**AGENDA
CITY OF CEDAR FALLS, IOWA
PLANNING AND ZONING COMMISSION MEETING
WEDNESDAY, OCTOBER 09, 2024
5:30 PM AT CITY HALL, 220 CLAY STREET**

TO: Planning and Zoning Commission
FROM: Chris Sevy, AICP, Planner II
DATE: October 9, 2024
SUBJECT: Request to vacate a 5-foot easement on property at 1907 Valley High Drive

TO: Planning and Zoning Commission
FROM: Jaydevsinh (JD) Atodaria, AICP, Planner II
DATE: October 3, 2024
SUBJECT: PC-2 District Site Plan – 924 W. Viking Road (SP24-010x)

SUBJECT: RP District Master Plan Amendment and Site Plan – Cedar Falls Bible Conference

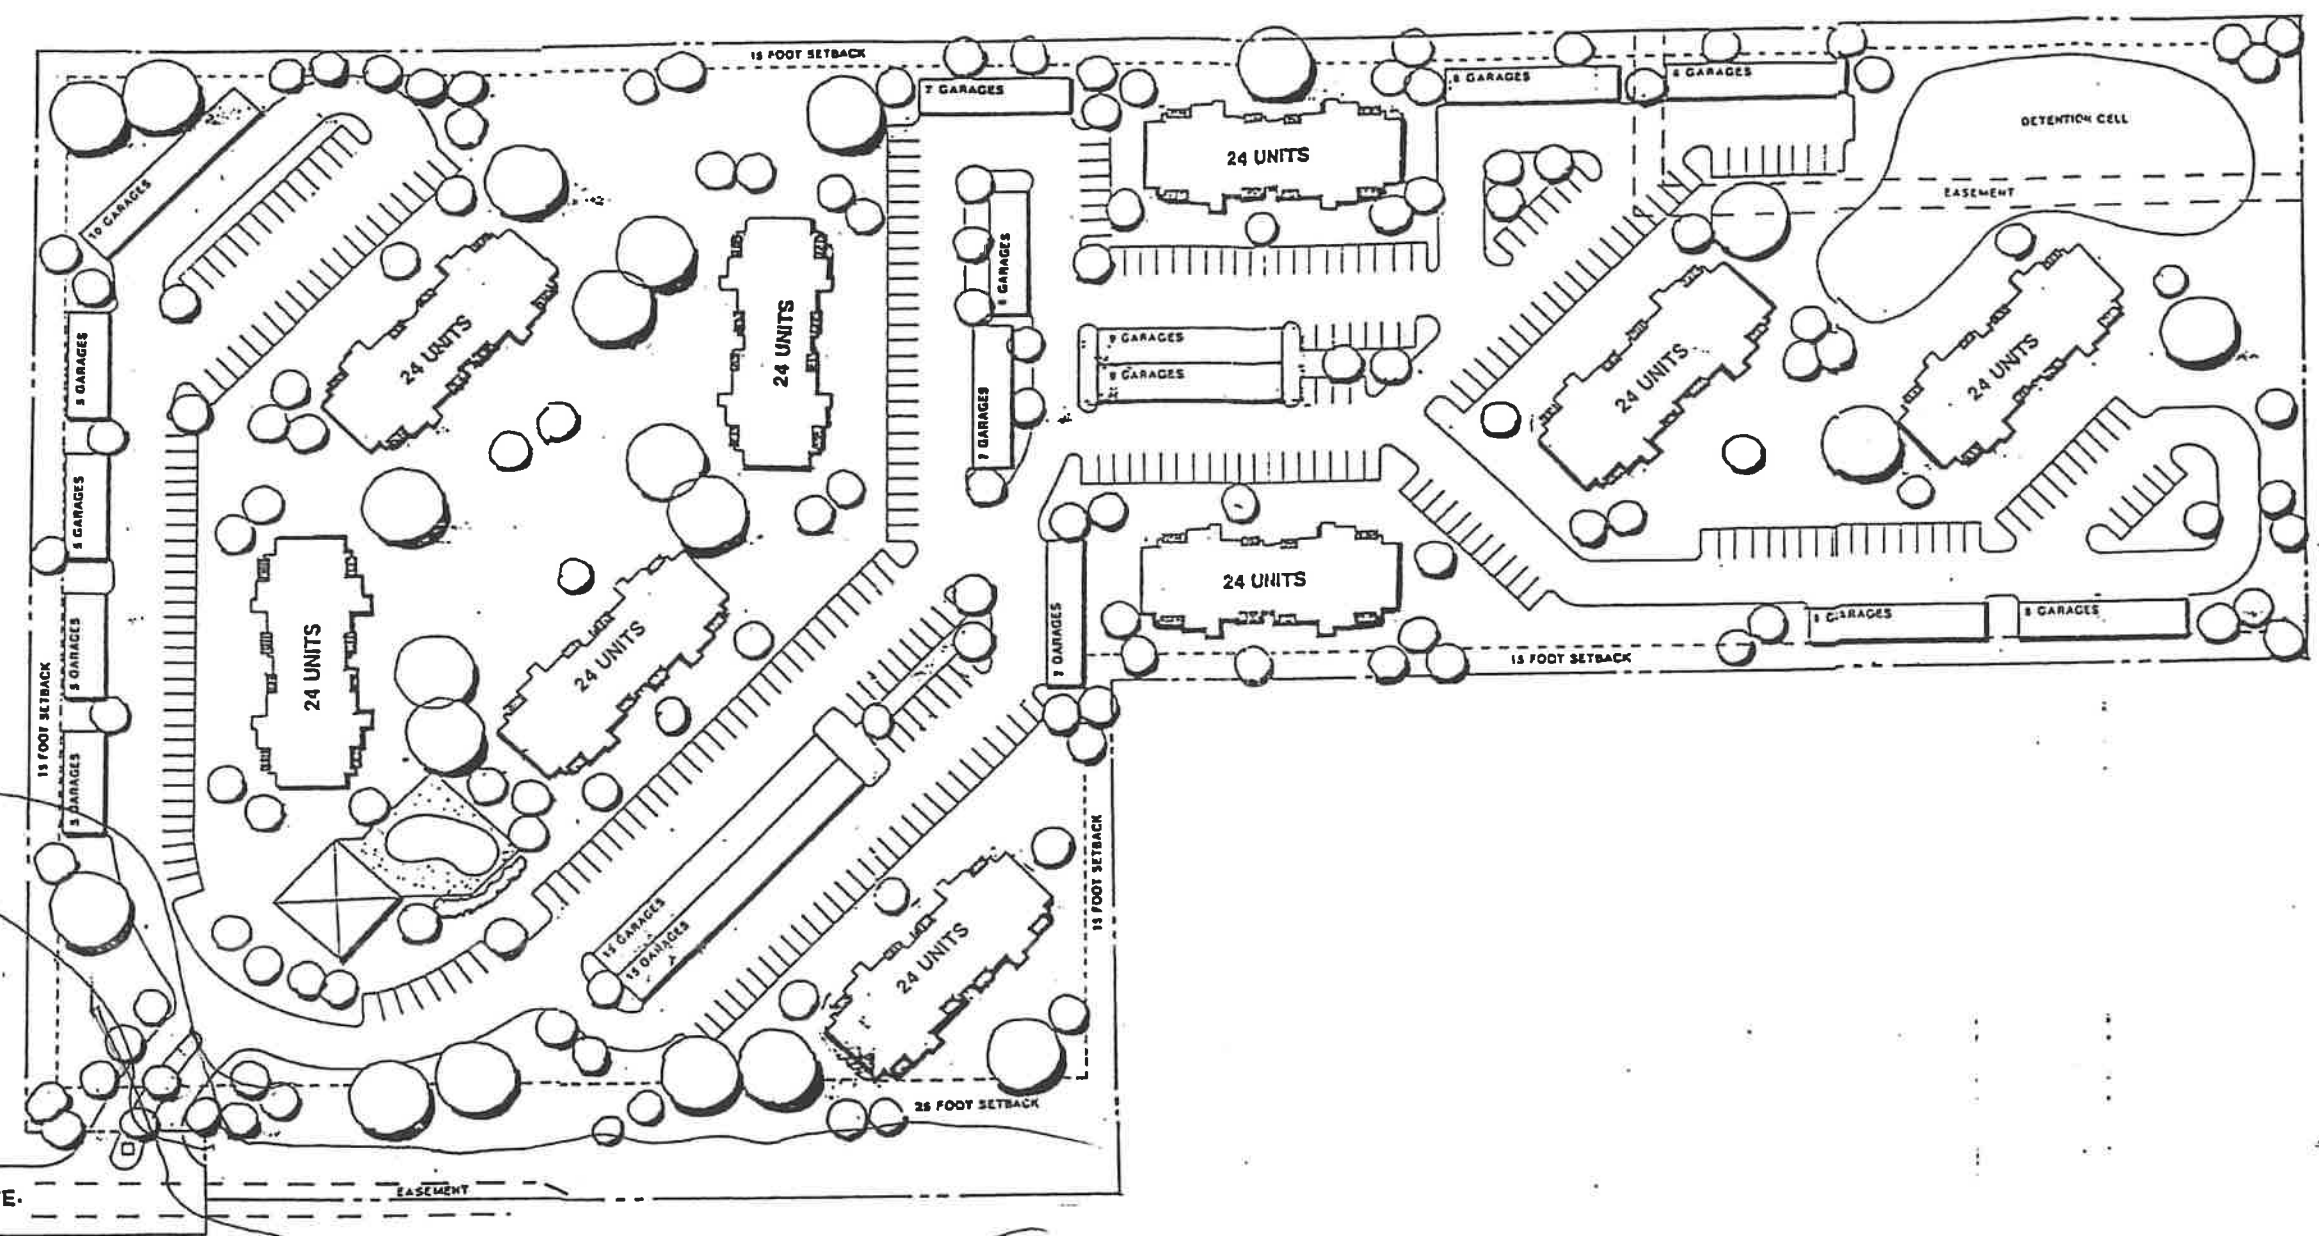
There are delineated wetland areas shown on the site plan that will be impacted by the development and stormwater facilities. The U. S. Army Corp of Engineers have reviewed and approved a mitigation plan for 1.8 acres of wetland and 0.06 acres of stream area that will be removed so the land can be developed. The mitigation plan requires the developer to purchase 1.8 acres of wetland credits and 1,481 stream credits from an approved wetland and stream mitigation bank in the service area of the impacts. Even though the wetlands will be removed, a stream channel will be maintained as a natural drainageway through the property. When detailed site plans are submitted for review, this stream channel and an appropriate buffer should be identified with details on how this area will be protected over time.

building and site plans are submitted. Staff notes some issues with how the sidewalks are currently shown, but these can be addressed at site plan review. For example, sidewalks are on the perimeter of the building sites and not providing clear pedestrian crossings to and between the buildings. For instance, on the image to the right, there is a sidewalk shown along north side of the south entrance from Lake Ridge Drive, but there is no clear pedestrian connection to the building site to the west. There is also no sidewalk shown along the north side of the private drive. All sidewalks and paths will need to conform with ADA standards and will be reviewed with the site plan(s).

The proposal shows landscape buffering along the west side of the site that abuts Winding Ridge Estates. The number of plantings appears to be adequate; however, no specific details have been provided on the plantings. Staff would recommend that the buffer opposite of the parking areas and garages be planted with evergreen trees to provide both privacy and noise reduction for those areas. The area where the proposed office use is shown will have buffering provided by the undisturbed wetland area. Robust landscaping in the buffer along the southern boundary of the site should also be provided, since the area to the south is platted but not yet developed for lower density residential buildings (1-4 dwelling units per building).
